**Technical Assistance Services for Communities**  
**Contract No.: EP-W-07-059**  
**TASC WA No.: R6-TASC-002**  
**Technical Directive No.: R6-Homestake Mining-02**

**Comments on Air Monitoring and Radon Issues Raised in the  
U.S. Army Corps of Engineers' Draft Remediation System Evaluation (Supplement)  
for the Homestake Mining Company (Grants) Superfund Site, New Mexico**

**May 6, 2010**

**Figure 1**  
**Air Monitoring Stations at the Homestake Mining Company Superfund Site**  
(Source: Baker, 2010b)

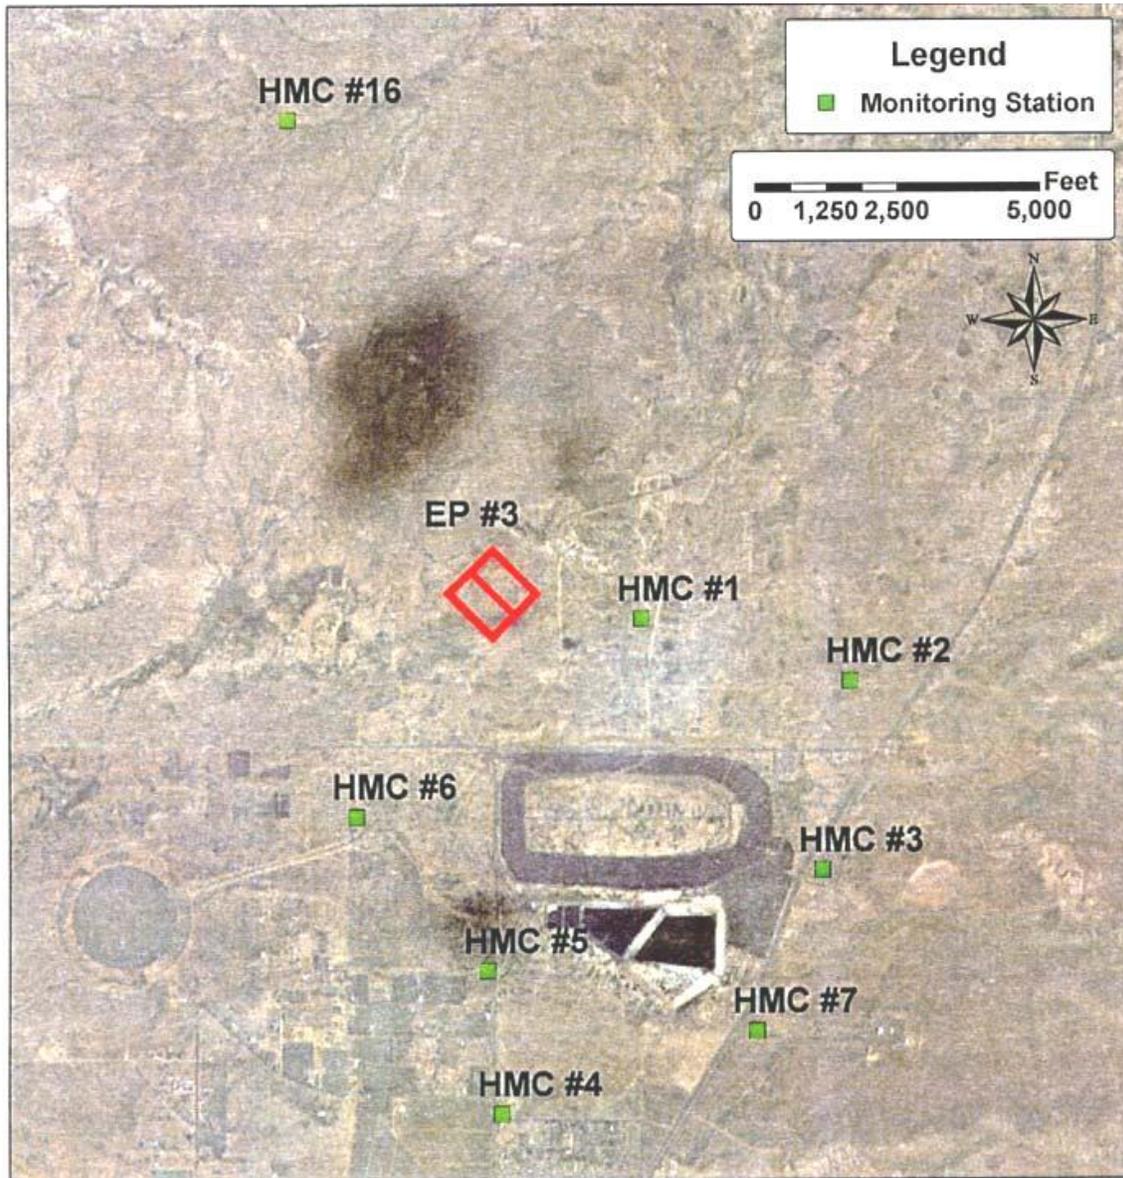
Results for monitor station HMC #16 are included in the background column of **Table 2** because this station, which is located about 2.75 miles northwest of the Large Tailings Pile (LTP), is designated as the background monitoring site for the facility. Results for HMC #4 and HMC #5, designated as "nearest-residence" monitoring sites, are shown in the "non-background" column of **Table 2** to differentiate them from HMC #16, the designated background monitor. Radon levels for monitors HMC #1, HMC #2, HMC #3, HMC #6 and HMC #7 were pooled into one average concentration and placed in the "non-background" column because these stations are sited at locations predicted to have the highest concentrations of airborne particulates (DRSE Report Supplement, p. 37).

<sup>1</sup> DRSE Figure 21 is a copy of a map that HMC has used many reports for at least the last decade, but which is now known to be incorrect with respect to the location of HMC #16. The more recent figure that is reproduced as Figure 1 in this report not only is stated to be accurate with respect to the location of HMC #16 (see, testimony of Kenneth L. Baker, January 12, 2010 (HMC, 2010; Exhibit 36B)), but is also more legible.

**Figure 2.**  
**Average Annual Outdoor Radon Concentrations\***  
**at Background Stations, BVDA Residential Area, and**  
**Nearest-residence Monitor (HMC #4), 1972-2009**

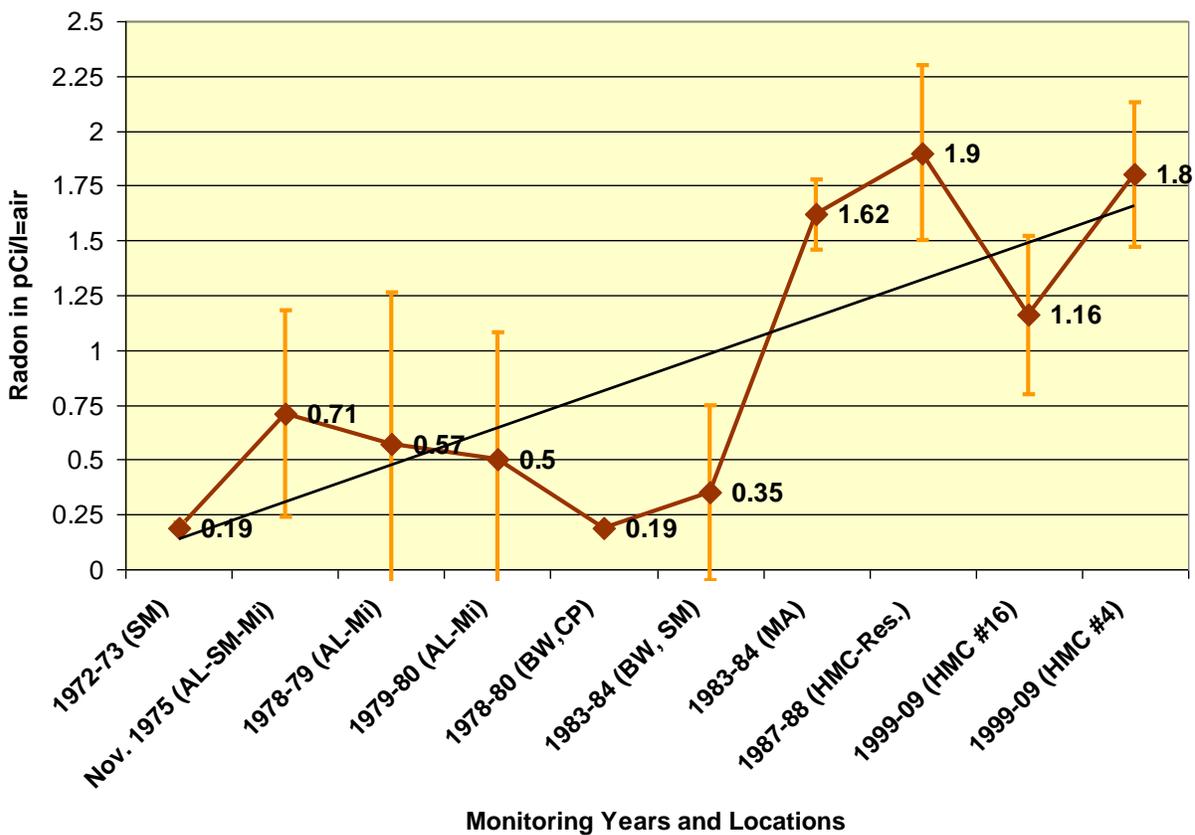
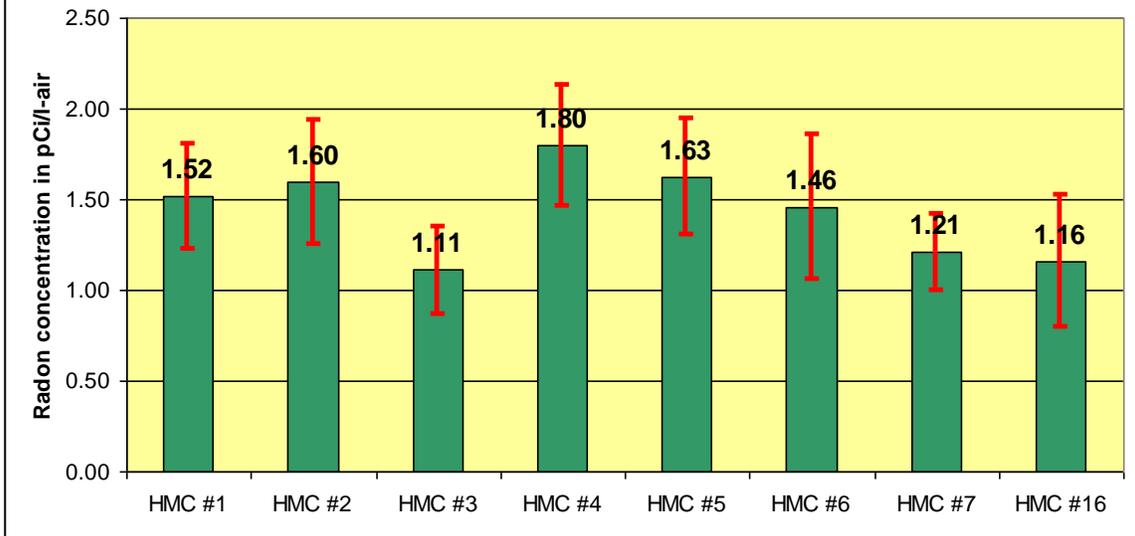
The plot in **Figure 2** appears to depict two groups of data: (i) concentrations at background sites ranging from 0.19 pCi/l to 0.71 pCi/l during the period 1972 to 1983; and (ii) average annual radon levels in the two residential studies (1983-84 and 1987-88), at HMC's background monitor (HMC #16) and at the nearest-residence monitor (HMC #4) between 1999 and 2009. The levels in the more recent group were significantly higher than those in the earlier group. A trendline applied to the data suggests an increasing trend in radon levels over time.<sup>2</sup>

The data in **Table 2** and **Figure 2** clearly show that outdoor radon levels approaching or exceeding 2 pCi/l have been detected in the residential areas next to the HMC site since at least the early 1980s. An overall increase above background of between 1.2 pCi/l and 1.7 pCi/l Rn-222 has been observed in or near the residential area over this time. At times, the radon levels in the neighborhoods next to the HMC site have been more than 10 times higher than the lowest background concentrations. The outdoor levels near the residences on average are five to six times higher than the average U.S. level (0.4 pCi/l) reported by EPA (2010). The persistence of average annual radon levels of 1.8 pCi/l and 1.63 pCi/l at the two nearest-residence monitors over the last 10 years indicates that the problem is not going away.

Figure 3. Mean Radon Levels of HMC Air Samplers, 1999-2009

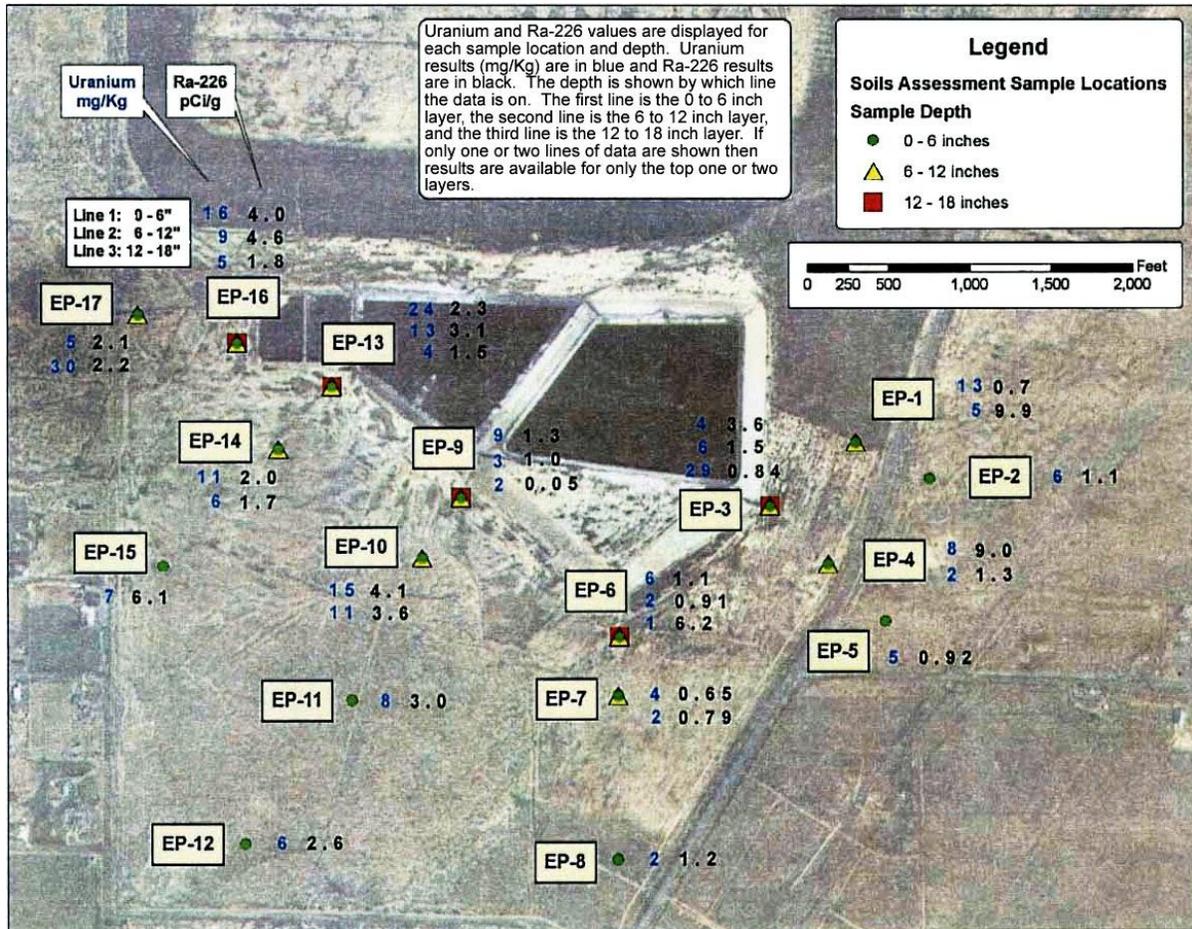
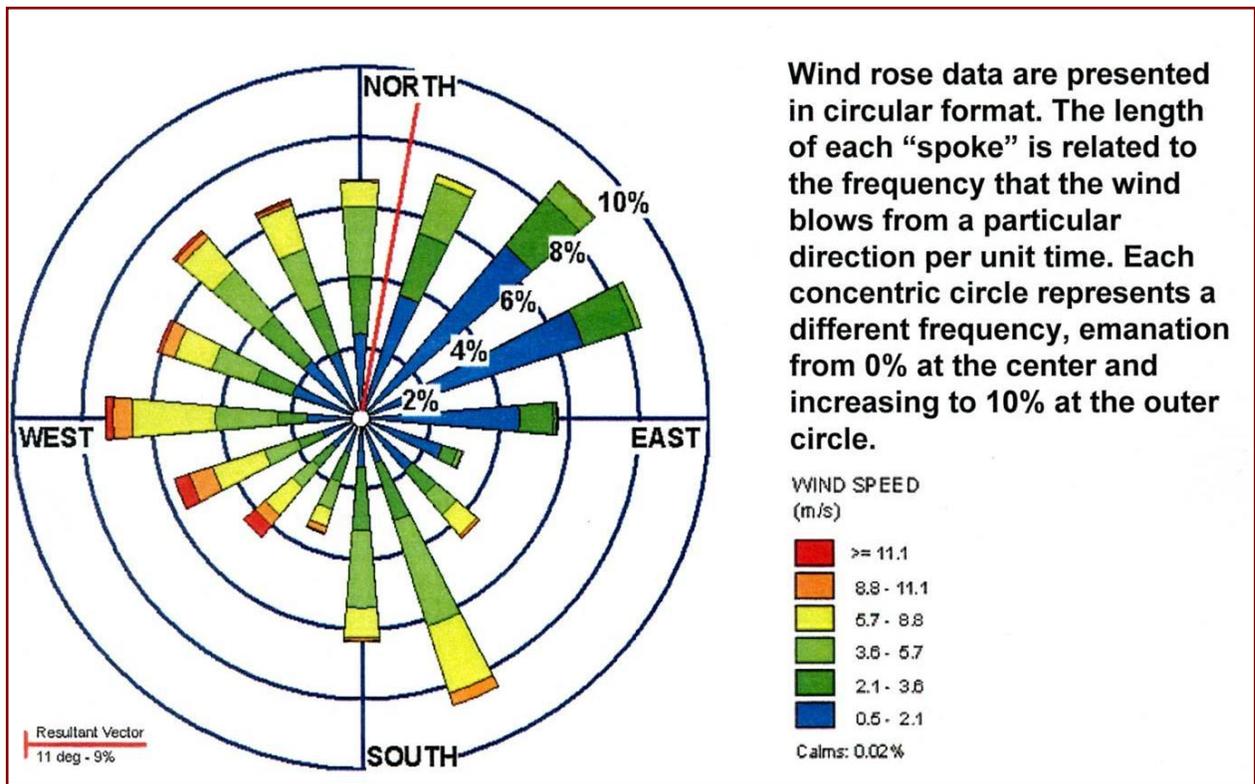
The results of a statistical analysis to test whether radon levels recorded at the two nearest-residence monitors, HMC #4 and HMC #5, are significantly higher than levels recorded at the background station, HMC #16, are shown in **Table 3b**. A t-Test for two samples (assuming unequal variance) was performed on the data set using the Excel Data Analysis function and assuming a normal distribution of the data.<sup>3</sup> Only two monitors, HMC #3, located 0.8 miles east of the LTP, and HMC #7, located within 1,000 feet of the Small Tailings Pile (STP), had radon levels that were no different than those levels recorded at HMC #16. Radon levels at the rest of the monitors were all significantly different than those levels measured at HMC #16. HMC #4 and HMC #5, the two nearest-residence monitors, had average annual radon levels significantly higher than those at HMC #16, with *p* values of 0.0000001 and 0.0002, respectively. This means that the probability that the average levels in the nearest-residence monitors were different than the average level in HMC #16 by chance only is infinitesimally small.

These analyses suggest that HMC #16 may be sampling a different population of ambient radon gas than all but two of the other perimeter monitors, and perhaps all of them. While the populations may be different, radon concentrations at all of the monitors around the HMC site and at the background site are still far greater than the background levels recorded elsewhere. These analyses validate the TASC Report's concern that HMC #16 may not represent true background radon levels (it is located within 3 miles of abandoned mines located next to Haystack Road), and add support to the RSE Team's recommendation for fresh characterization of background by adding two or three new monitoring stations (DRSE Report, pp. iv, 37, 47).
